AGENDA REPORT

MEETING DATE:	November 16, 2026	Regular
DEPARTMENT:	City Manager	Steven Krokoff, City Manager Steven Krokoff Steven Krokoff (Nov 12, 2026 17:18:08 EST)
SECTION OF AGENDA:	New Business	November 16, 2026
AGENDA ITEM TITLE:	Consideration of an Addendum to the Purchase and Sale Agreement dated September 21, 2026, regarding the acquisition of the Verizon Place property regarding Tower Approvals.	
STATEMENT OF PURPOSE:	To approve the tower locations and satisfy the City's contractual tower-approval obligations, contingent upon closing and conveyance to the Development Authority of Milton, while establishing provisions for future access and utility/fiber easement relocation.	
FINANCIAL IMPACT:	The proposed temporary-location amendment leaves the $26,250,000 purchase price unchanged.	
RECOMMENDED ACTION:	Approve the addendum in the final form reviewed by the City Attorney and authorize the Mayor to execute it.

1. Addendum regarding Tower Approvals;
2. Exhibit H-1 Verizon One DRAN relocation plan set, including permanent site, access/utility, screening, and encroachment plans; applicable easement instruments and legal descriptions.
3. Exhibit H-2 temporary tower preliminary

SHEET NUMBER:
C2

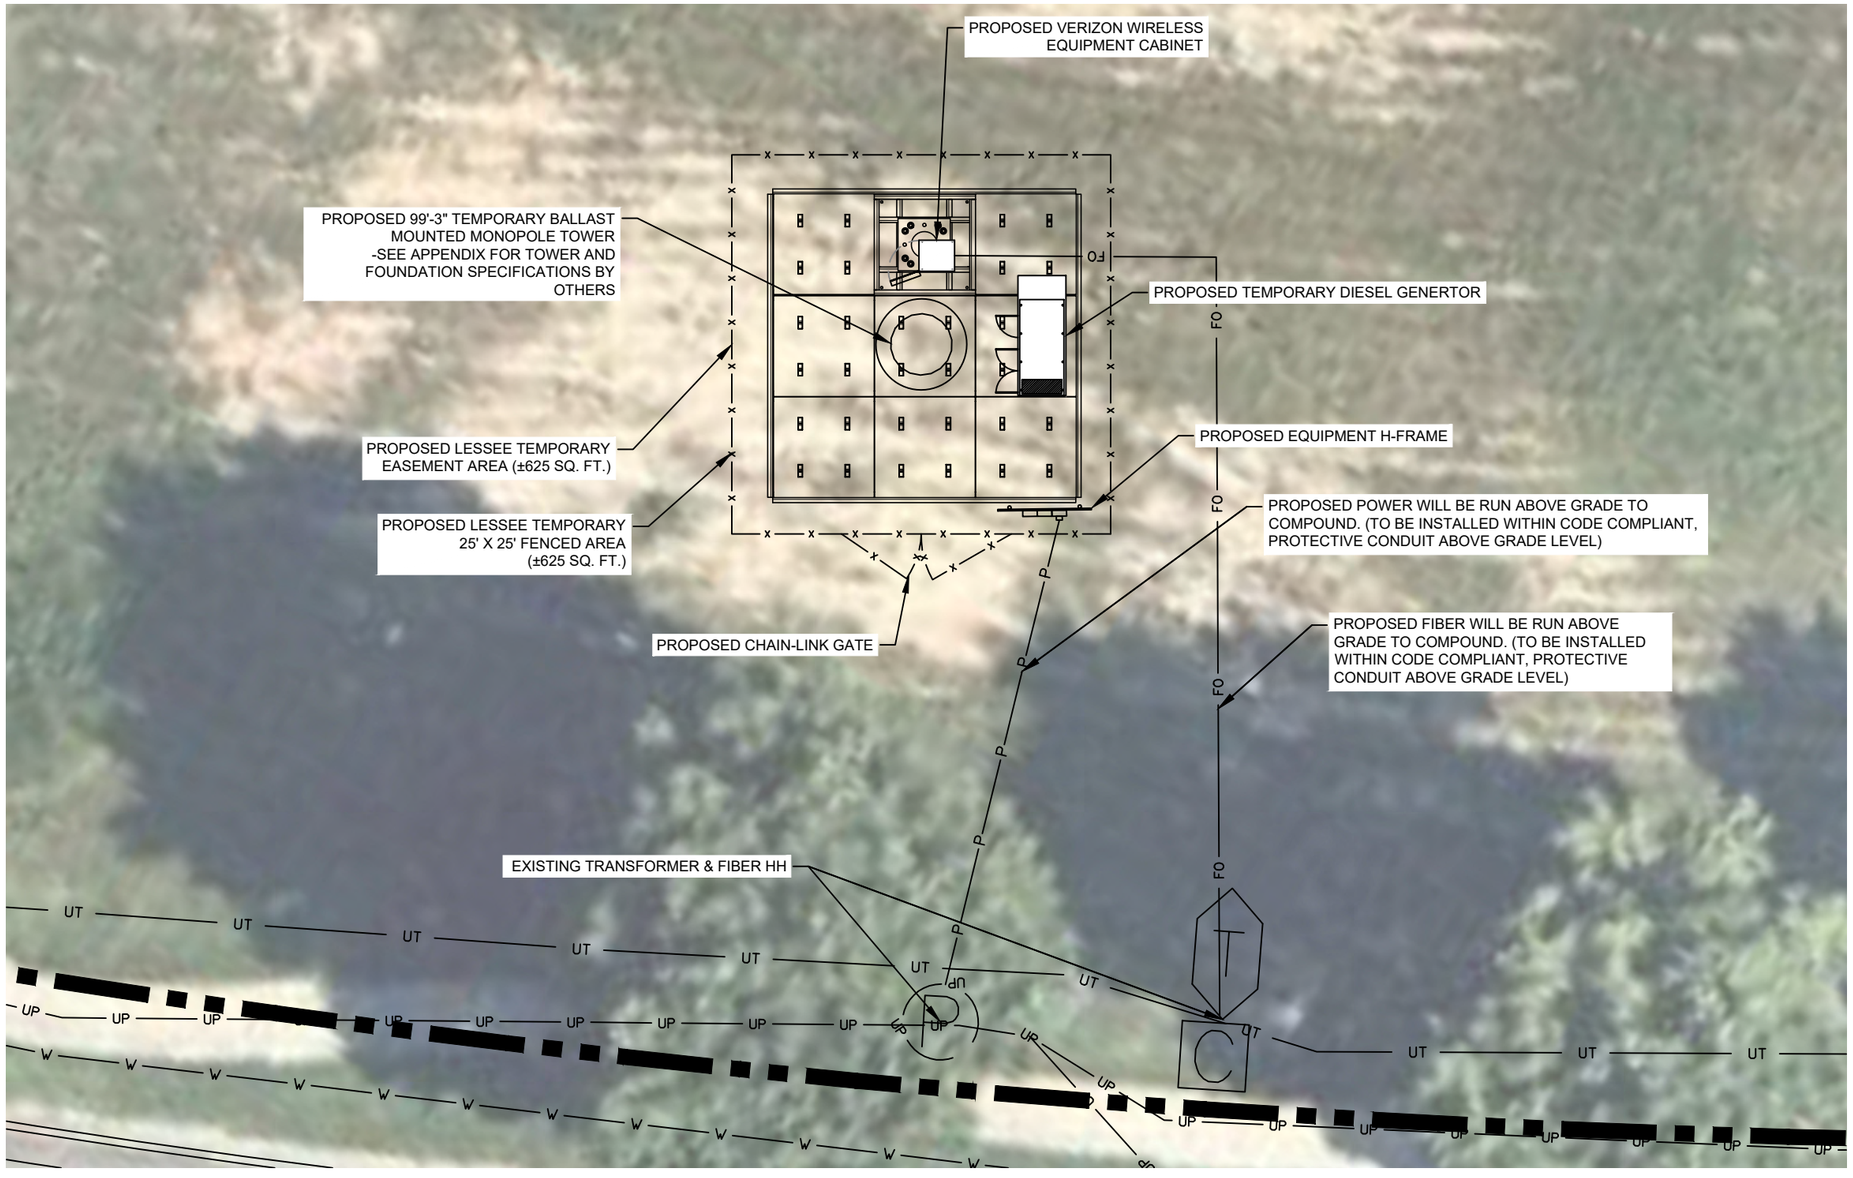
The drawings locate the compound near the existing retention pond and existing transformer and fiber handhole. Power and fiber would run above ground in code-compliant protective conduit (sheets C2 and C3). The 625-square-foot compound should not be treated as the full area affected by installation, because the utility connections extend beyond it.

SHEET NUMBER:
C3

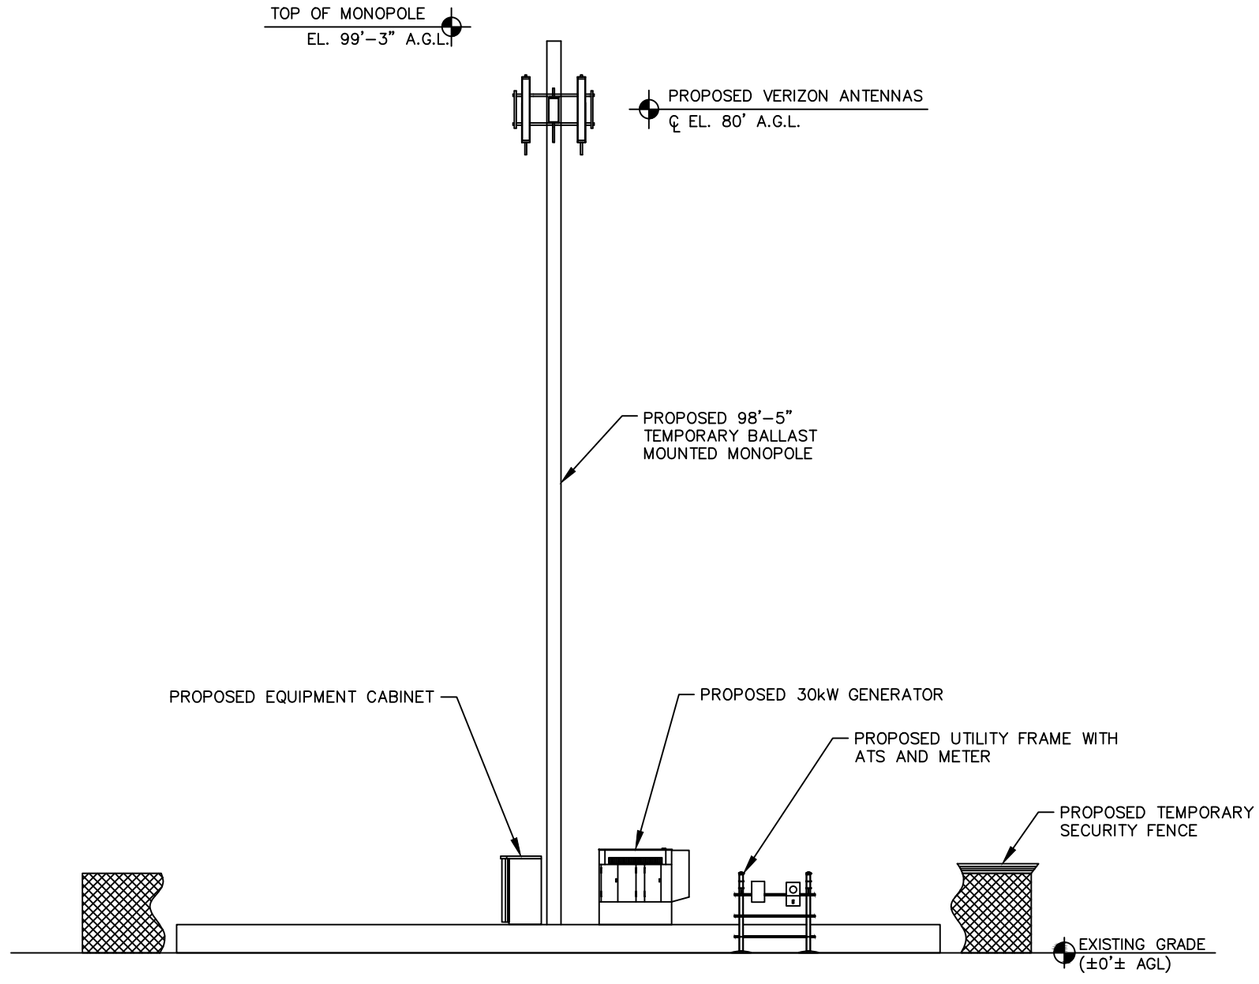
Exhibit H-2 is marked "Preliminary" and "Not for Construction." Its site information is reproduced from aerial imagery for illustrative purposes, and sheet C3 refers to tower and foundation specifications by others. The exhibit describes the proposed configuration; it does not establish that final engineering or permit review is complete.
